Location reference: Essex 5

# Norwich to Tilbury is a proposal for a new electricity transmission connection. It will play an important part in connecting low carbon, more affordable electricity from where it is generated to where it is needed.

# What we are proposing to change in your area and why

## **Area of proposed change February 2025**

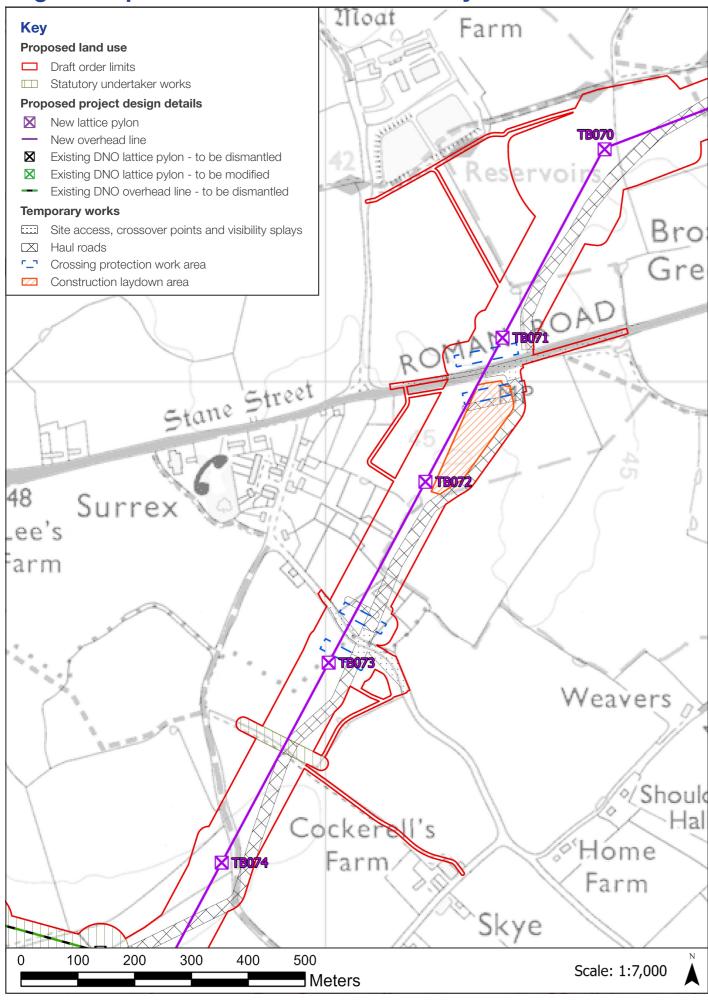
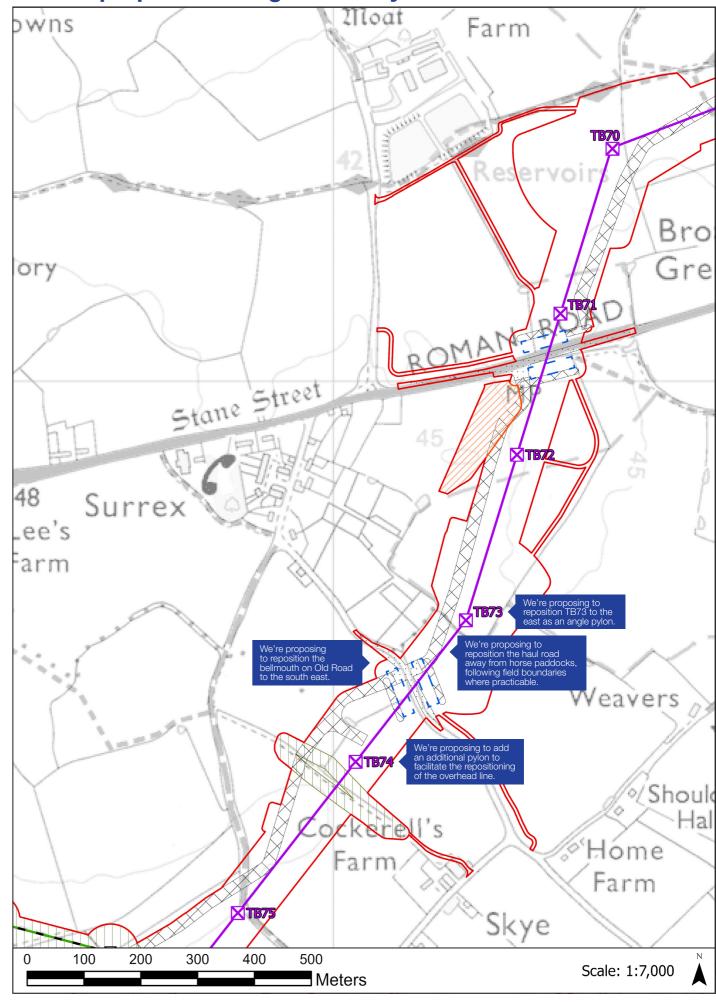
We are proposing to reposition a line of pylons near Surrex, to the east of the position presented at our statutory consultation in summer 2024. You can see the alignment presented at our consultation in summer 2024 and our proposed changes on the maps overleaf. The proposed change would affect the location of the pylons TB71 to TB75 (previously presented at statutory consultation in summer 2024 as TB071 to TB074).

The proposed change would include the addition of one further angle pylon to position the line more evenly between residential properties in the settlement of Surrex and the residential properties at Skye Green. This would remove the need for the haul road to cross the horse paddocks to the south of Surrex. We are also proposing to change the haul roads associated with these pylons so that they follow field boundaries where possible, reducing the impacts on land uses and agricultural activity, along with other minor amendments to the order limits.

To accommodate the proposed repositioning of pylons, we are also proposing to move the bellmouth on Old Road, where project traffic would cross the road, to the east of the location we presented at statutory consultation in summer 2024. This would facilitate access to the construction sites for the relocated pylons.

This is in response to consultation feedback which asked us to consider:

- increasing distance from residential properties
- changing the haul road to avoid isolating horse paddocks
- reducing the effect of the scaffolding requirements where the line would cross the A120.
